Village of Chenequa Plan Commission
Monday, February 12, 2024 at 6:00 p.m.
31275 W. County Road K, Chenequa, WI 53029

STAFF REVIEW

Subject: Site Plan Review

Project Description: Proposed Remodel/Addition to a Legal-Nonconforming Structure

G100

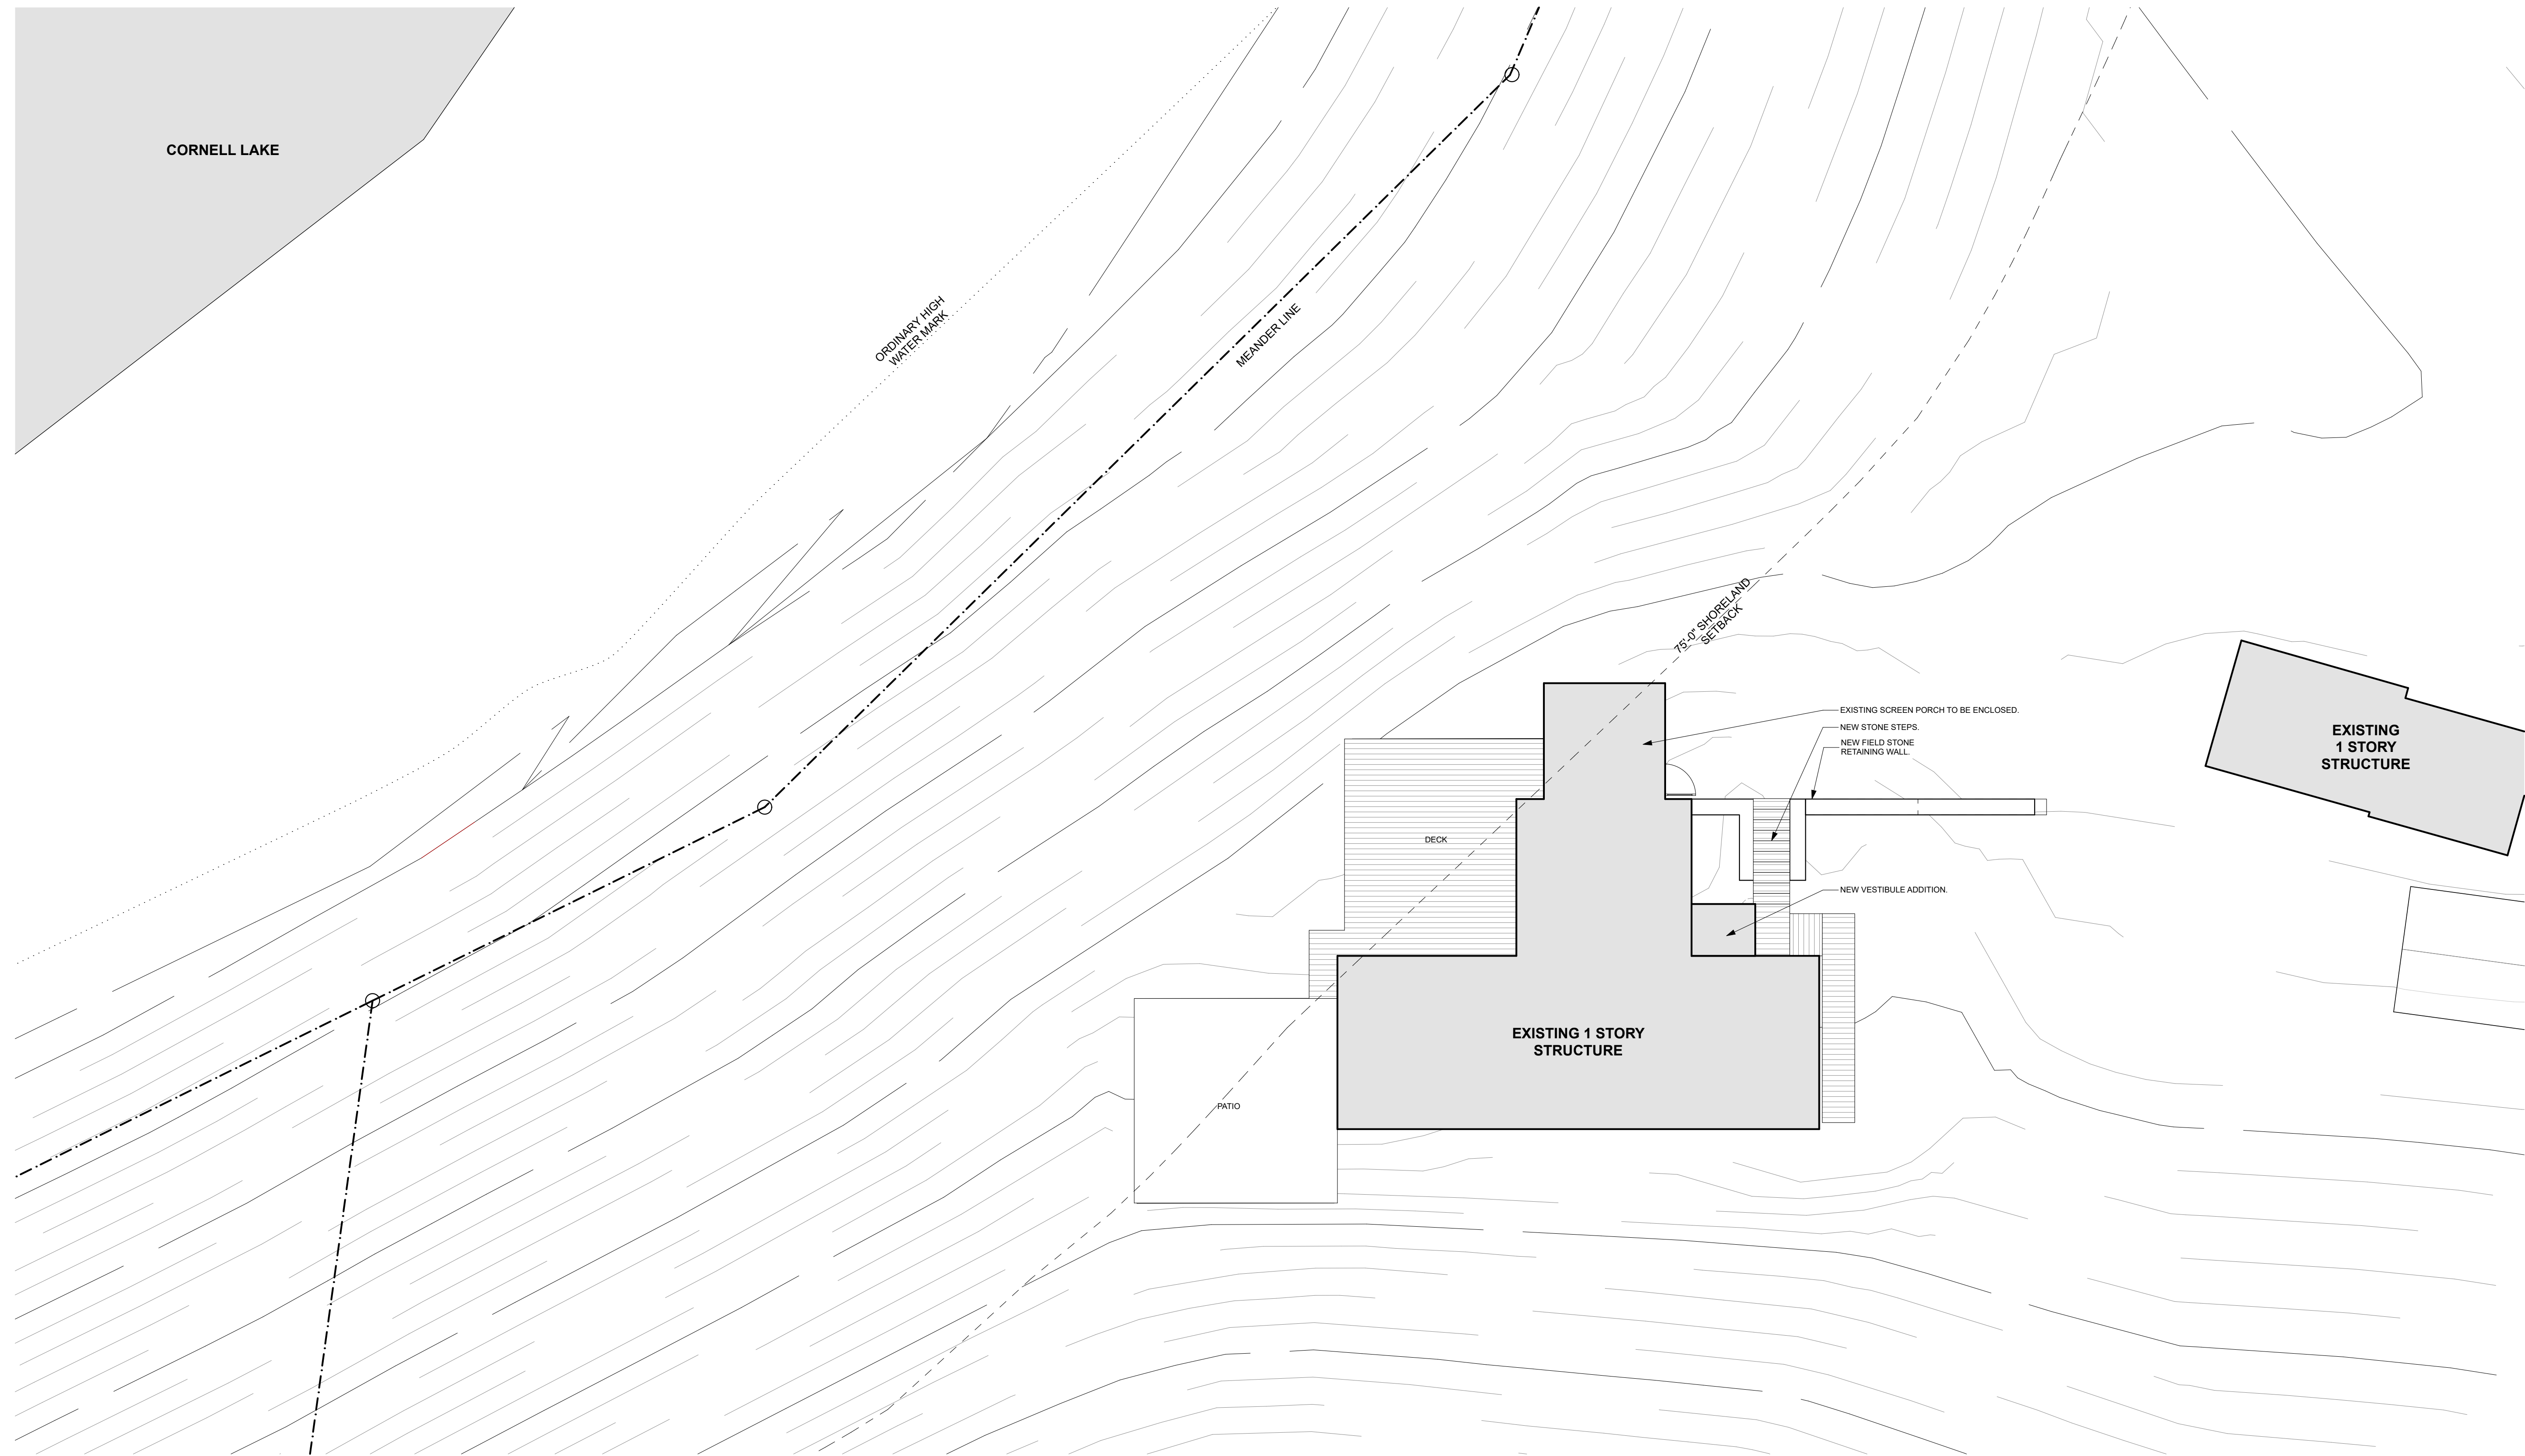
4. The applicant also proposes to remove the existing block wall on the west side of the structure and replace it with a new wall
 - a. The new wall will be constructed of fieldstone (see sample photo on G100)
 - b. The new wall will also incorporate stone steps (see sample photo on G100)
 - c. yard setback
5. There are currently no proposed trees to be removed within the 75' setback of Pine Lake
6. If one acre or more of land is to be disturbed, a DNR land disturbance permit shall be obtained at least fourteen (14) days prior to beginning of construction.

**ARCHITECTURAL SITE PLAN**
SCALE: 1/8" = 1'-0"

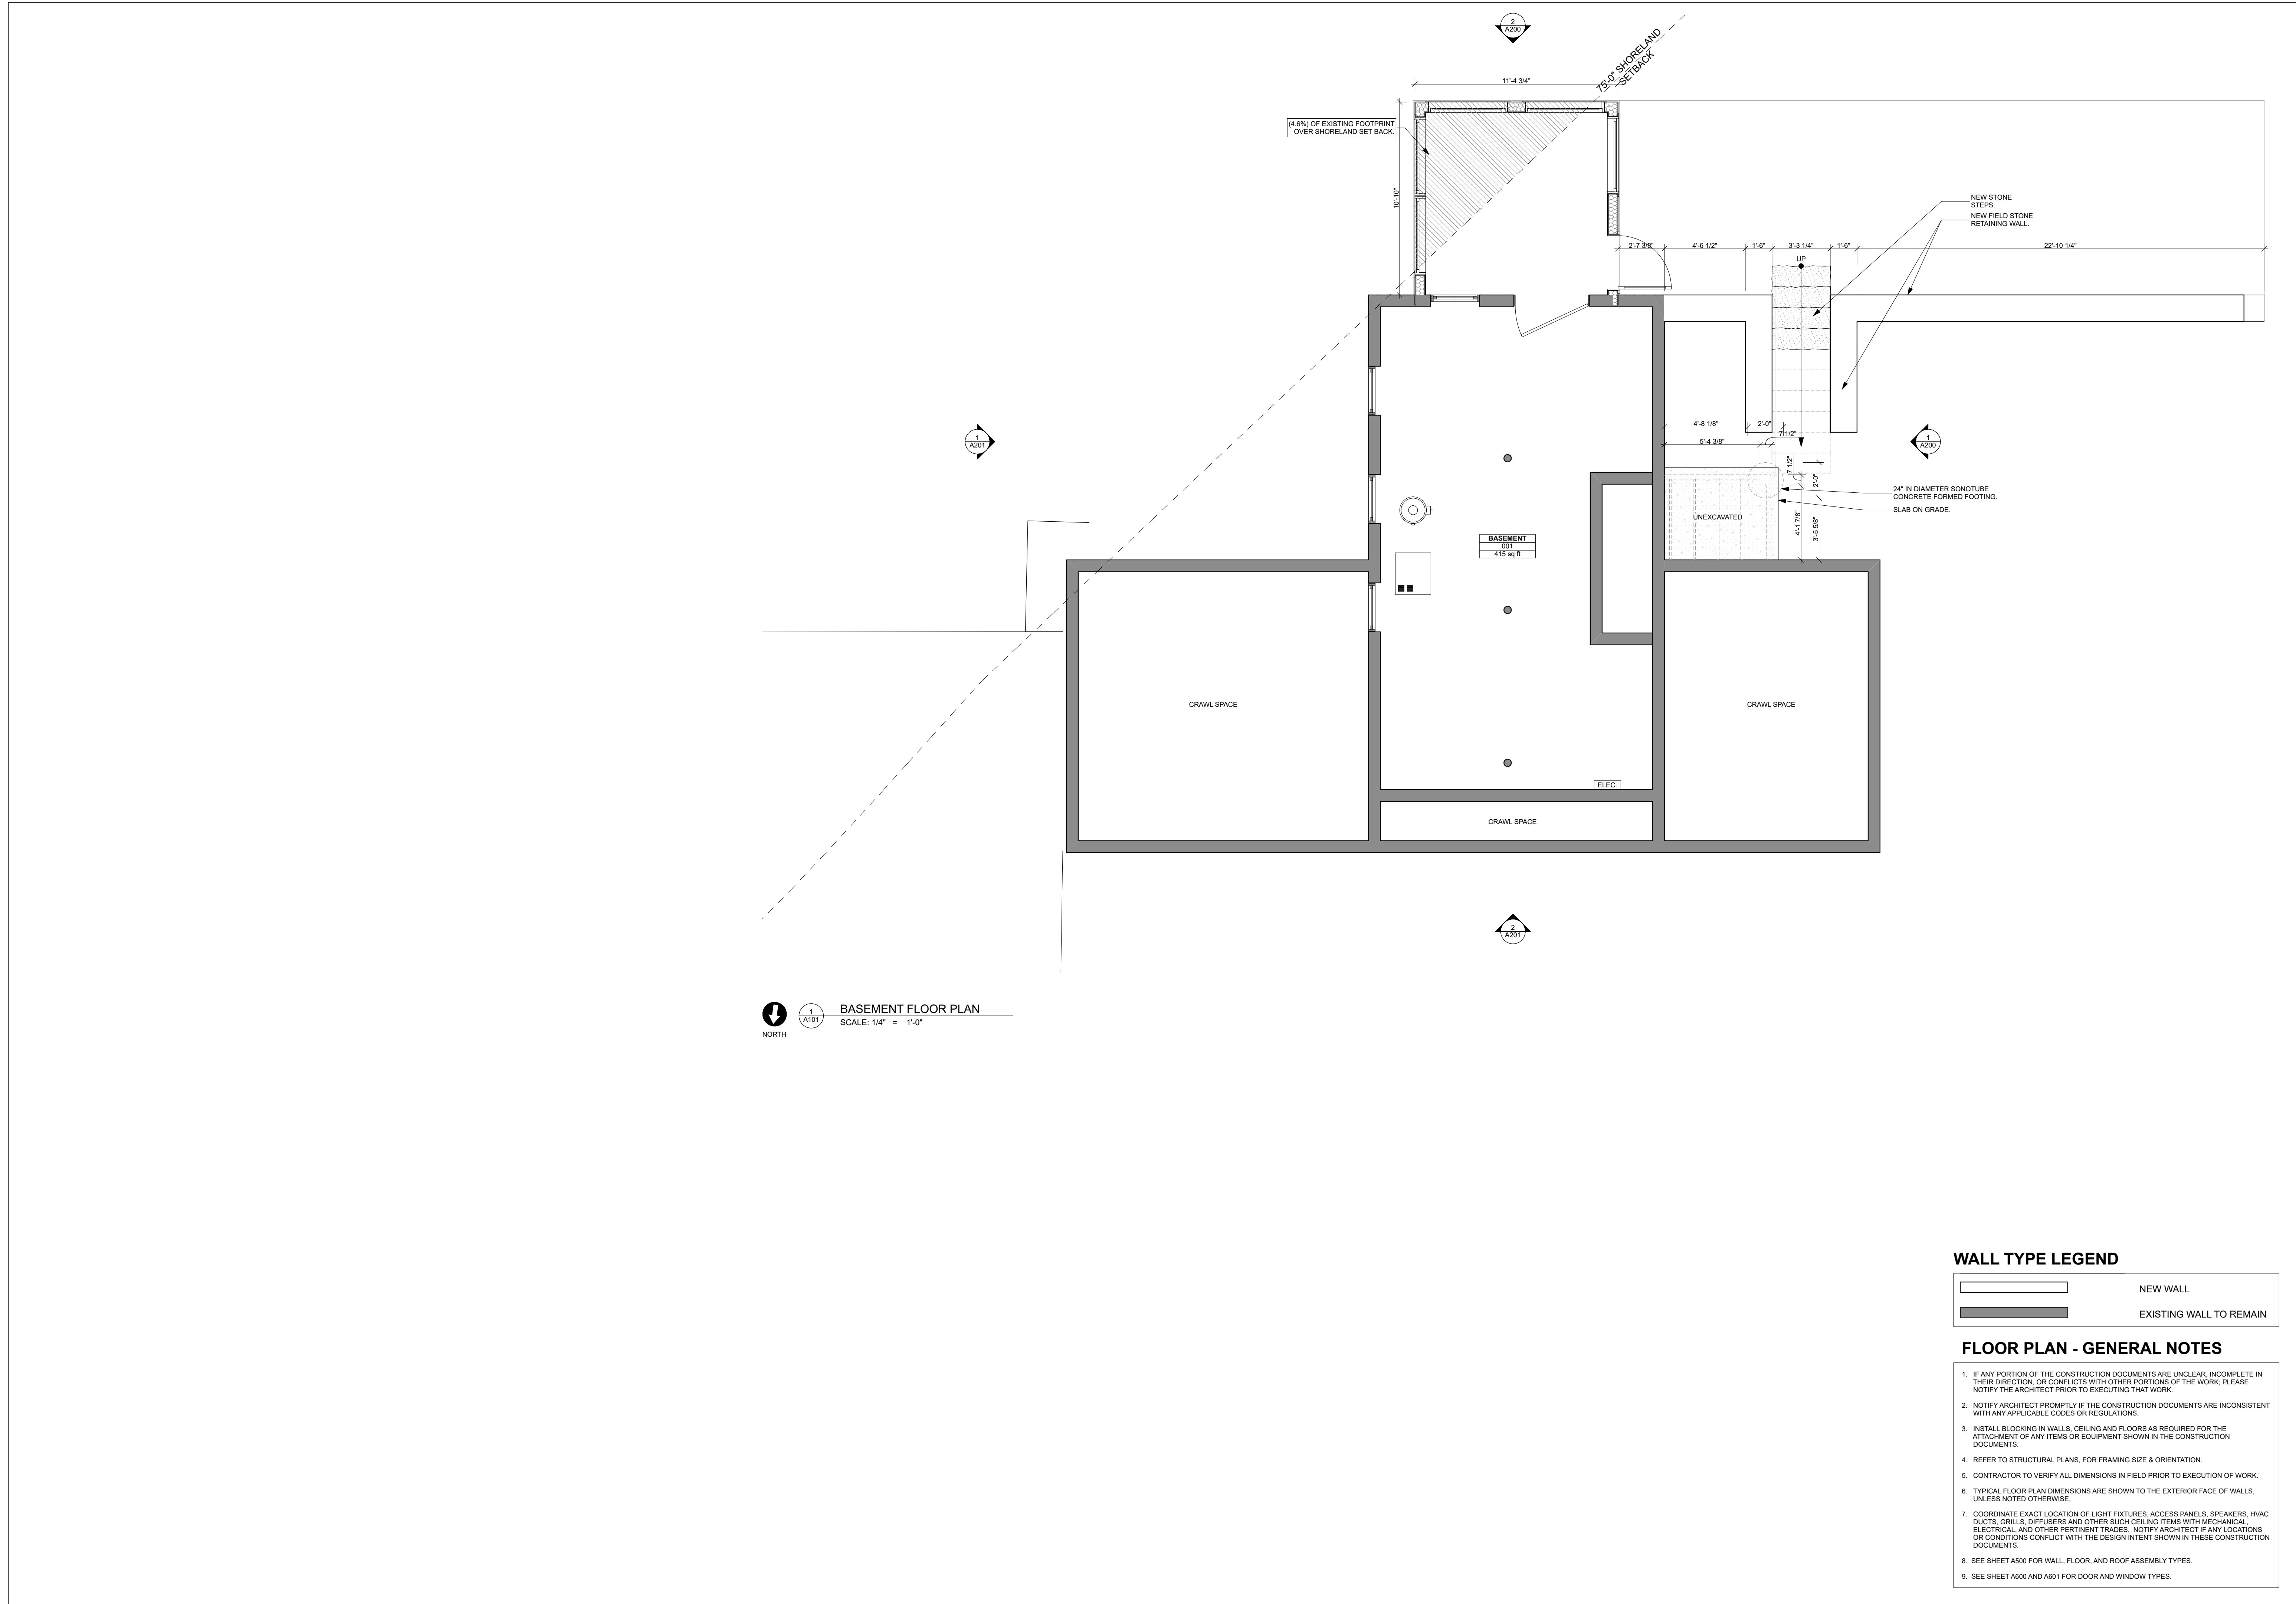
- c. Page A001 provided by Galbraith Carnahan Architects depicts the portion of the structure that is partially within the 75’ setback from the OHWM of Cornell Lake.
